## Application for Licence Amendment

<b>Licence Number</b>	L9208/2019/1
<b>Licence Holder</b>	Salt Lake Potash Limited
<b>ACN</b>	117 085 748
<b>File Number</b>	DER2019/000338
<b>Premises</b>	Lake Way Potash Project Goldfields Hwy WILUNA WA 6646  Legal description –  Mining tenement M53/796, M53/797, M53/798, M53/123 & M53/910, and part of mining tenement M53/53
<b>Date of Report</b>	17/11/2020
<b>Decision</b>	Revised licence granted

L9208/2019/1

**Figure 1: Layout of constructed ponds**

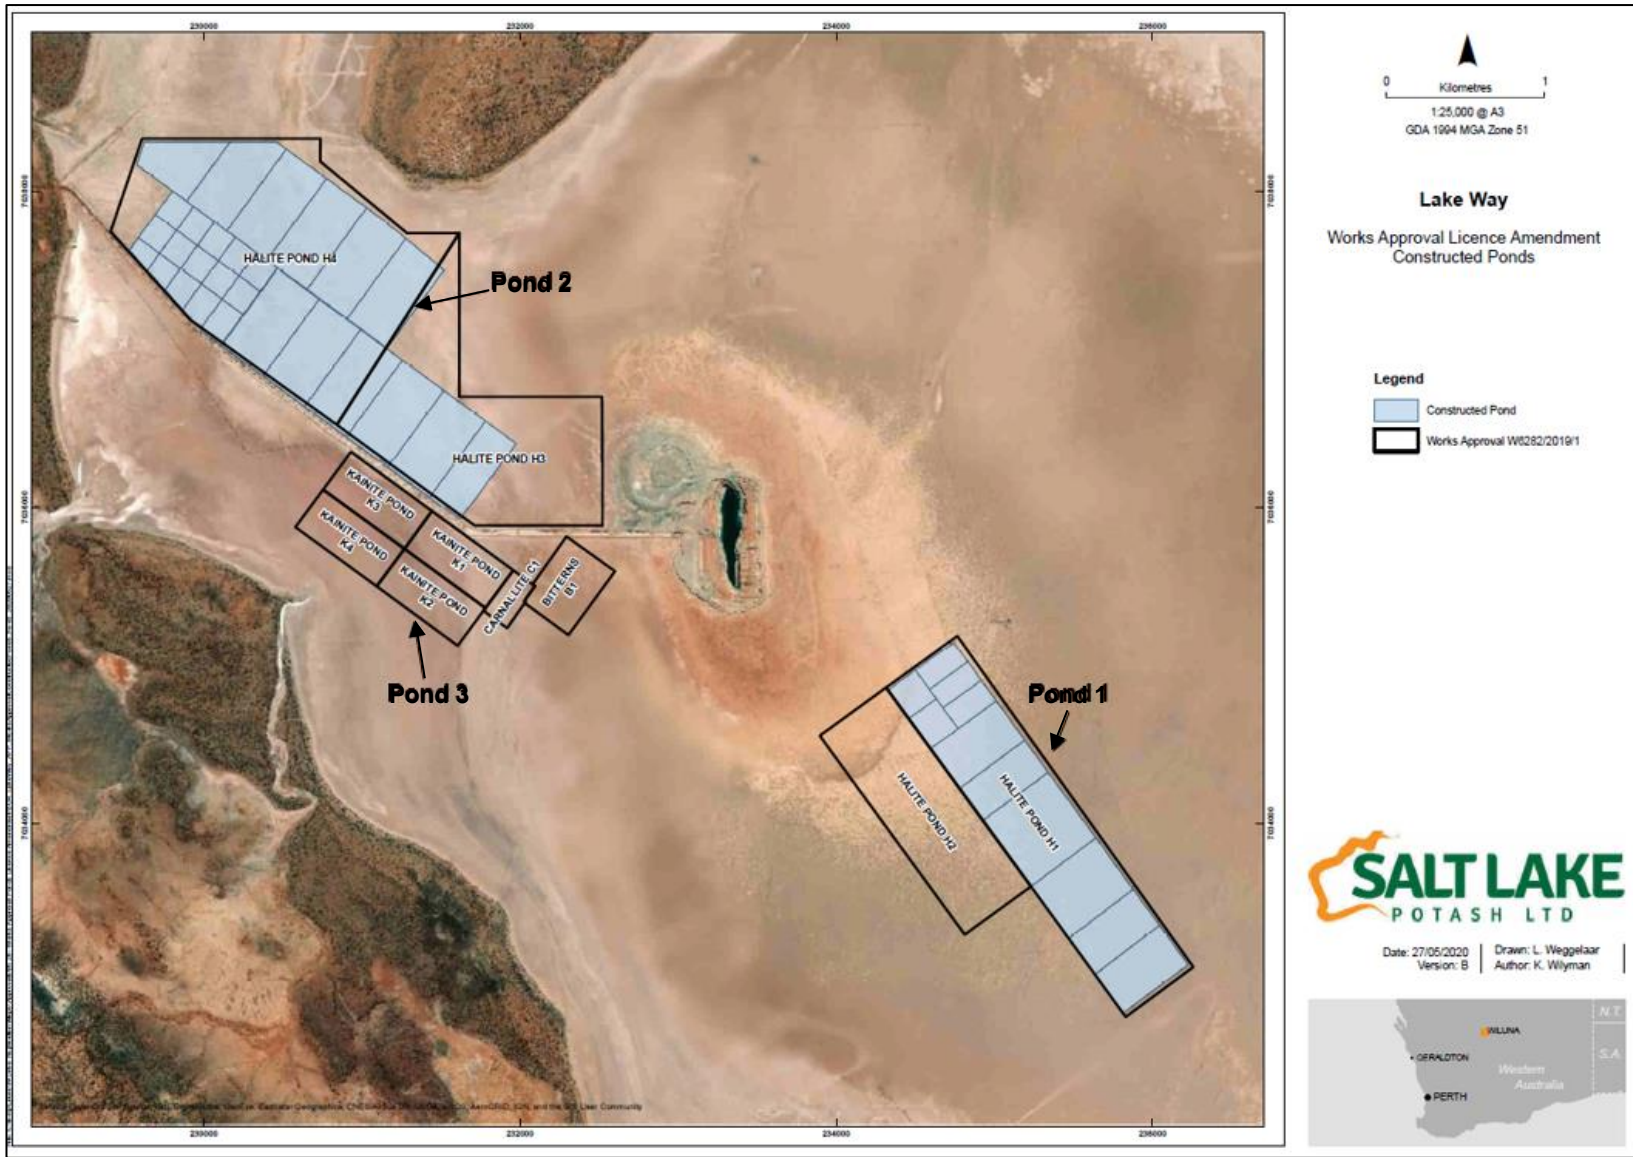
Condition	Licence Holder Response	DWER response
		DWER requested a map showing the position of Pond 1 and Pond 2 (clearly labelled) and the entire premises boundary displayed.
<b>Additional Comments</b>	The Australian Standard stipulated in the draft licence (AS/NZS 5667.12:1999 -Guidance on sampling of bottom sediments) is intended for use in sampling "...sedimentary materials from inland rivers and streams; lakes and similar standing bodies; and estuarine and harbour areas". It is not evident SO4 that this standard is intended for use in sampling industrial pondage. Salt precipitate in an industrial pond system is not comparable to transported sediment in natural water bodies.	The condition referring to this standard has been removed.
<b>Comments received on 5/11/2020</b>		
Condition /page	Licence Holder Response	DWER response
<b>Decision report - administrative errors</b>	Licence holder has pointed out a few administrative errors in report.	These errors have been corrected.
